UNITED STATES PATENT AND TRADEMARK OFFICE

APPLICATION NO.	FILING DATE	FIRST NAMED INVENTOR	ATTORNEY DOCKET NO.	CONFIRMATION NO.
10/608,671	06/27/2003	Michael J. Pugia	MSA-3452	5201
7590 05/17/2006			EXAMINER	
Elizabeth A. Levy Bayer HealthCare LLC Two Edgewater Drive Norwood, MA 02060-4637			SINES, BRIAN J	
			ART UNIT	PAPER NUMBER
			1743

Office Action Summary

DETAILED ACTION

FIG. 2

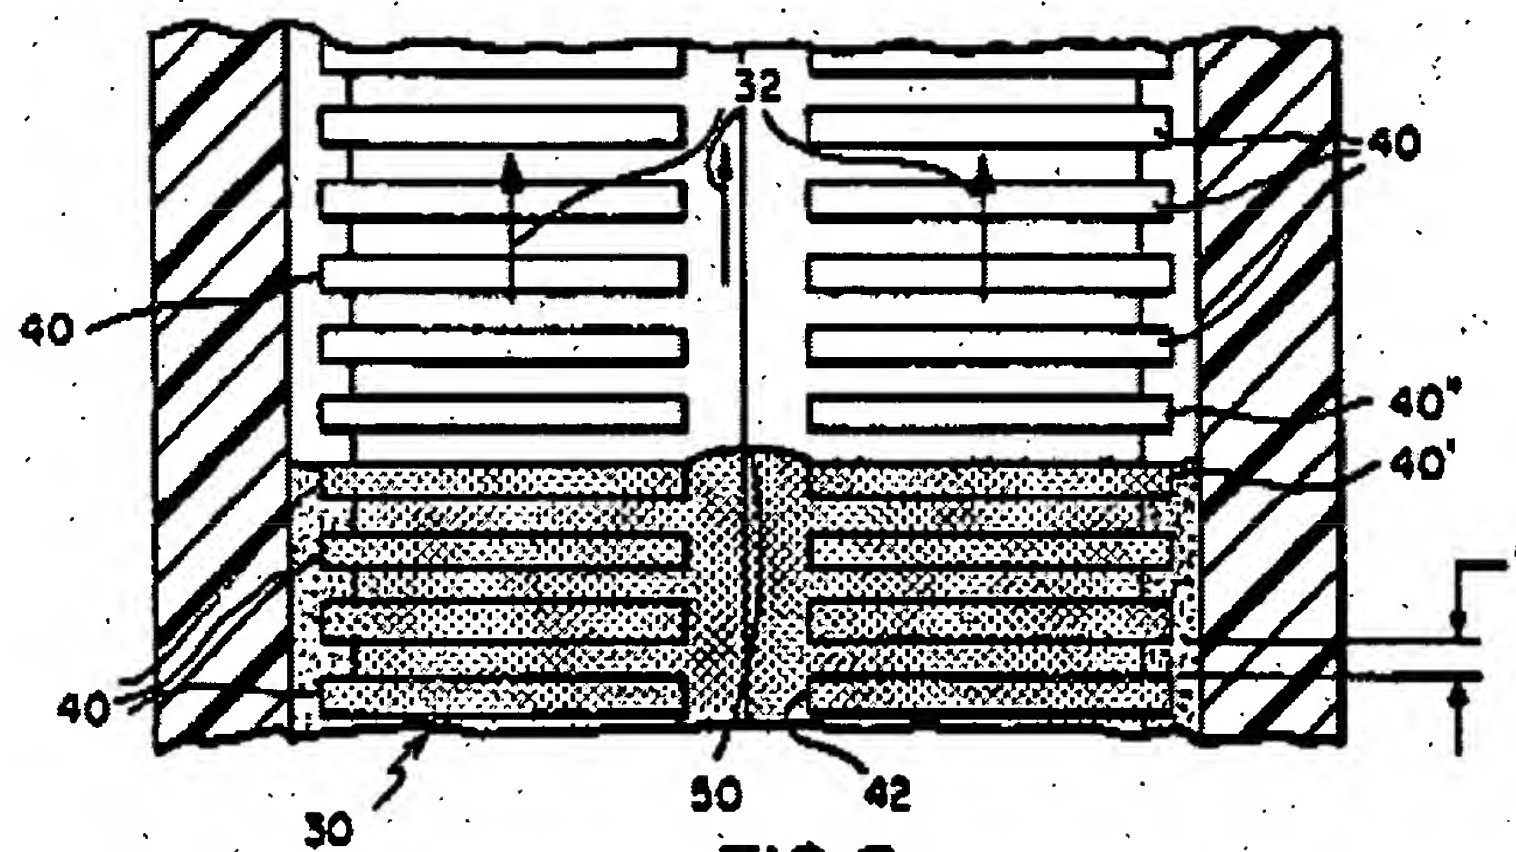
Regarding claim 2, Columbus '476 teach the incorporation of groove or slot structures (142g') within the apparatus. Columbus '476 anticipates an enclosed passageway (e.g., enclosed

transport zone 30) via the placement of cover top member 16 and bottom member 18 (see col. 3, lines 25 – 50; figures 1, 2 & 5).

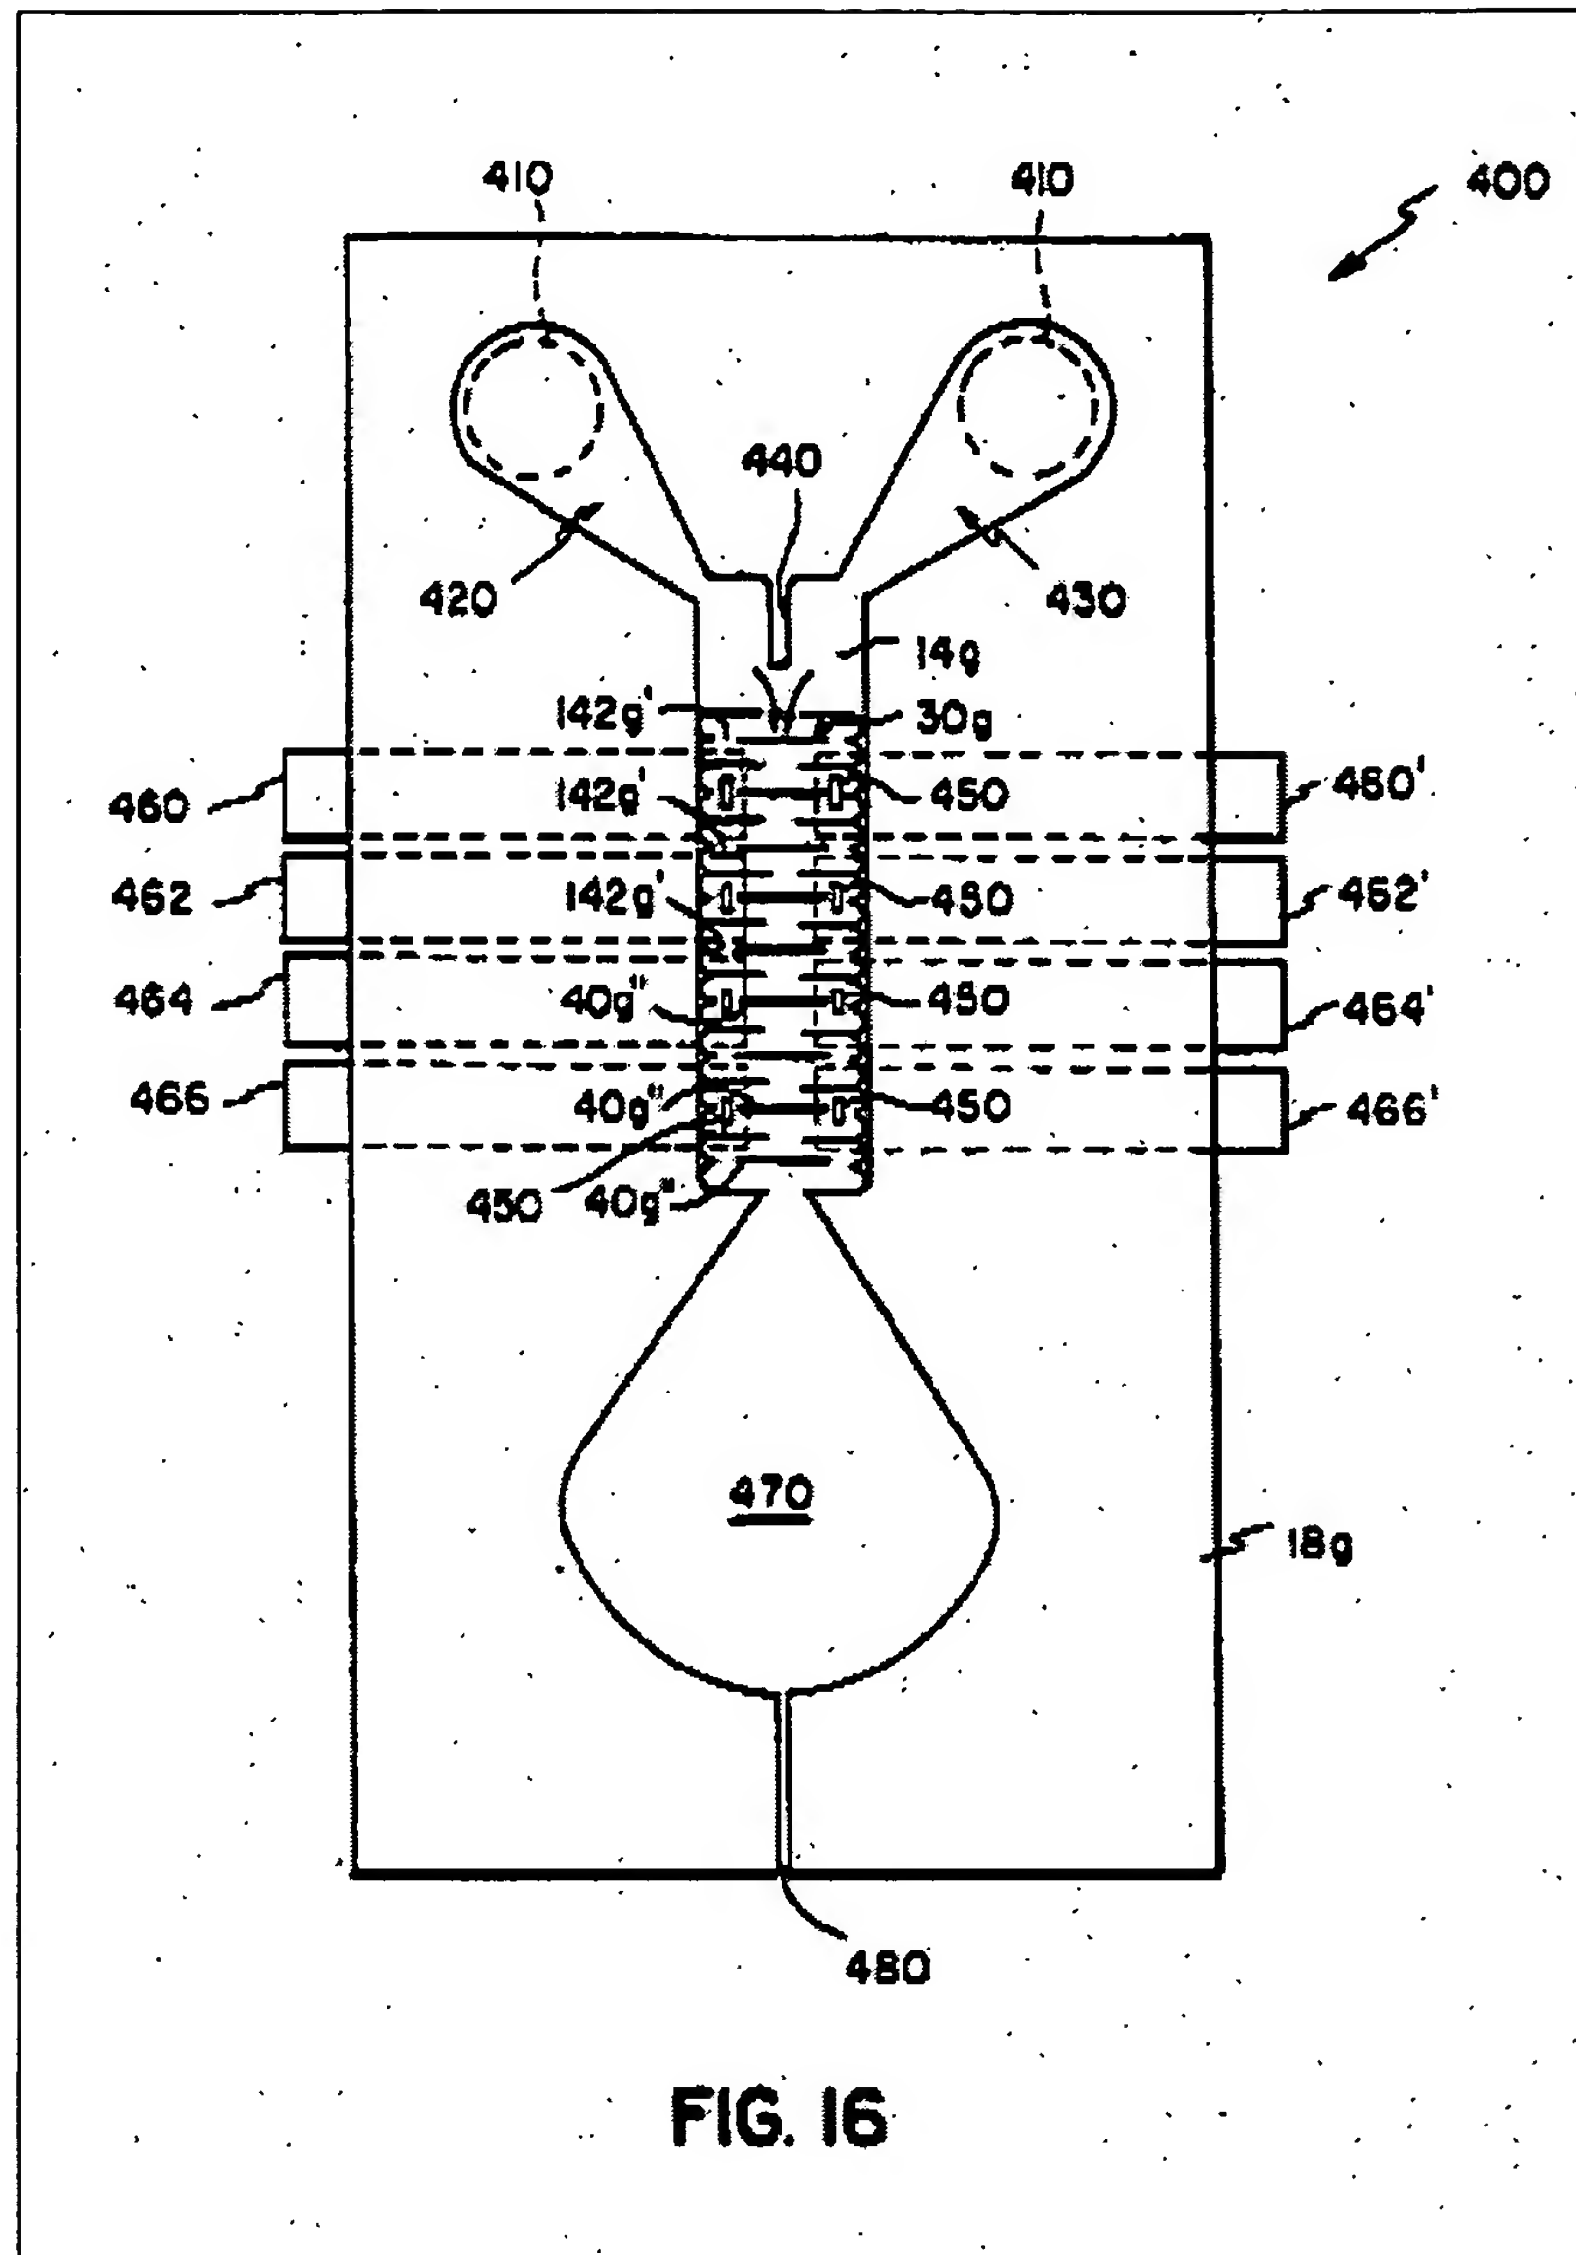
Regarding claims 1 and 3, as shown in figure 16, Columbus '476 teaches a microfluidic apparatus (multiple test element 400) comprising: an inlet port (inlet aperture 410); a capillary passageway (liquid delivery capillary zones 420 & 430) in fluid communication with the inlet port (410); an inlet chamber (capillary transport zone 30g) in fluid communication with the capillary passageway (420 & 430), wherein the inlet chamber comprises means (e.g., rib structures 40g", which are structurally equivalent to a weir structure) for uniformly distributing sample fluid across the chamber and displacing air from the chamber; and at least one vent passageway (e.g., vent aperture 480) at a side opposite the entry of the capillary passageway (see col. 7, lines 15 – 64; figure 16).

Regarding claim 9, Columbus '476 teaches the incorporation of an overflow cavity or chamber (470) within the apparatus.

Fig. 3b

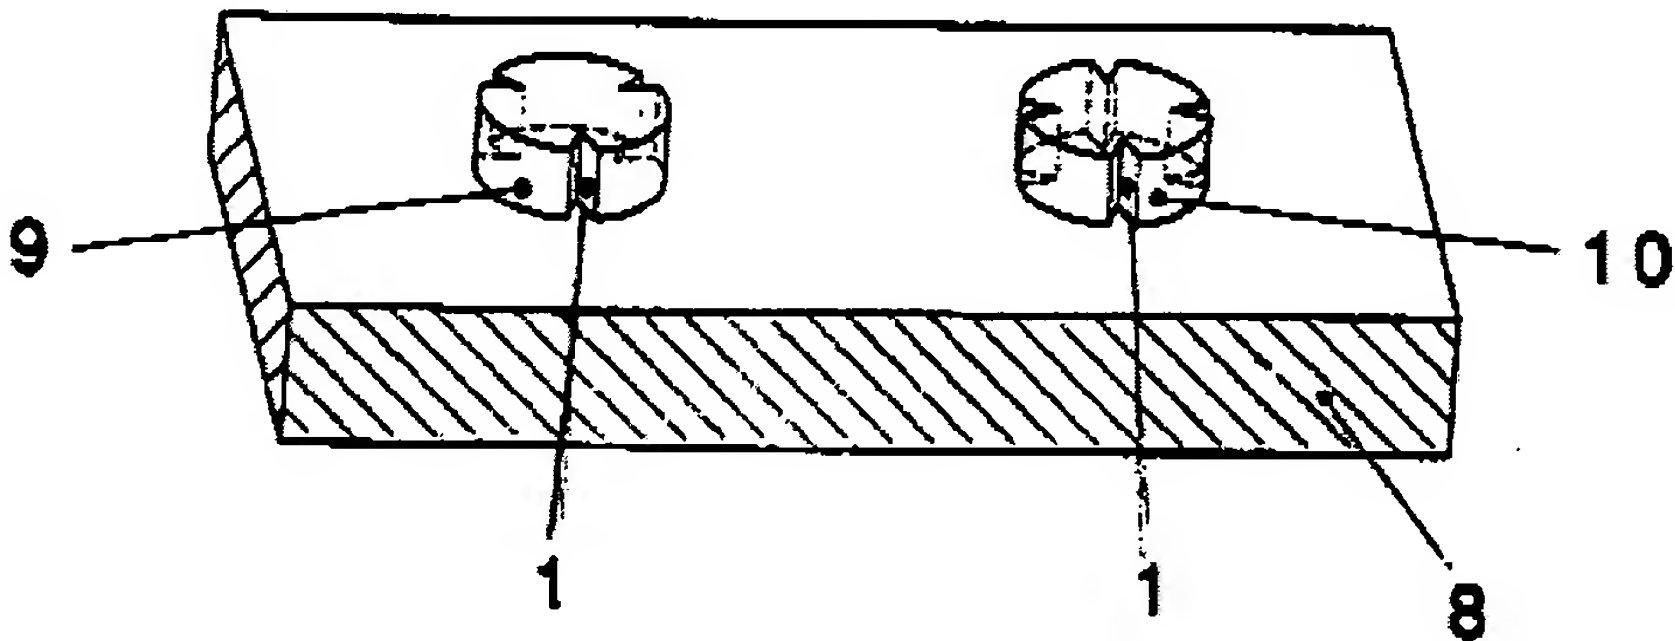
1. Claims 4 – 6 are rejected under 35 U.S.C. 103(a) as being unpatentable over Columbus '029 in view of Peters (U.S. Pat. No. 6,296,126 B1). Regarding claim 4, Columbus '029 is silent to the specific teaching of incorporating wedge-shaped cut-out structures with the microfluidic apparatus. As shown in figure 3b, Peters does teach the incorporation of wedge-shaped cut-out structures (columnar projection 9 having wedge-shaped cut-outs 1) within a microfluidic apparatus for facilitating effective fluid control within a microfluidic device (see col. 1, line 10 – col. 6, line 67; figures 1a, 3b & 4).

Regarding claims 5 and 6, as shown in figure 3b, these cylindrical or columnar projections (9) comprise essentially post structures, which extend from the base-plate (8), having wedge-shaped cut-outs (1) (see col. 5, lines 1 – 15).
